PREVOST

**WARRANTY
BULLETIN**

WB13-58

DATE :	OCTOBER 2013	SECTION :	01 - Engine
EXPIRATION:	OCTOBER 2015		
SUBJECT :	AIR INTAKE HOSE REPLACEMENT

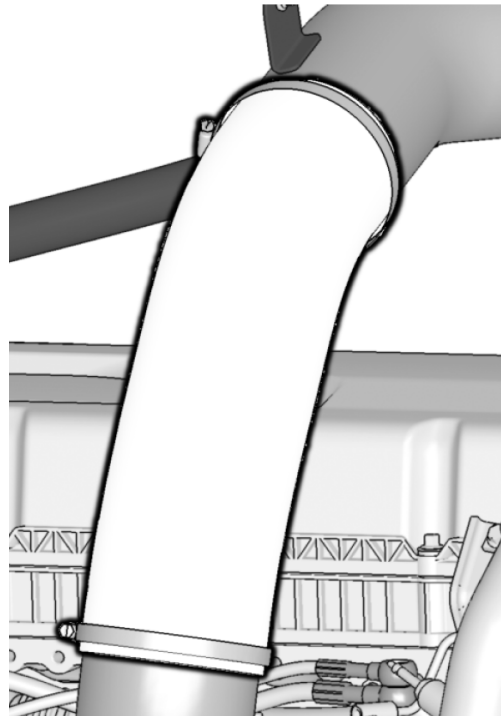
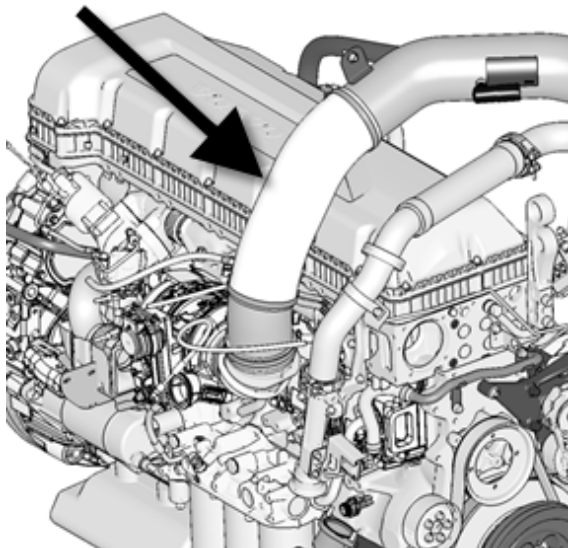
On the vehicles affected by this bulletin, change the flexible hose at the engine air intake.

1. On the engine, locate this air intake flexible hose on the left side of the engine.

2. Remove the clamps and hose
3. Install a clean cap on engine air intake to protect from dust and debris.
4. Replace by new hose #033195 and #504786 clamps.

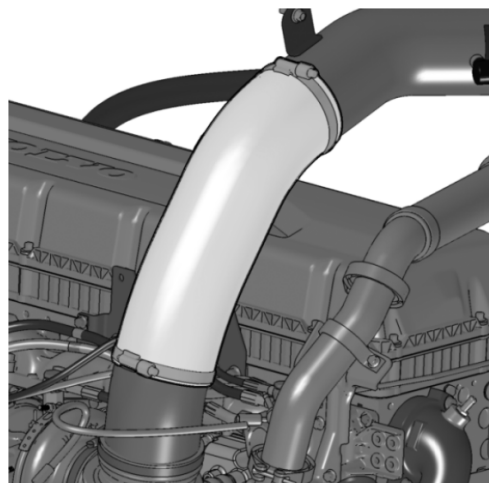
Attach lower clamp to support provided in this area.

5. Pay particular attention to the tail of the clamp to make sure it does not touch any hoses in the surrounding area.

Re-orient or shorten the tail if required.
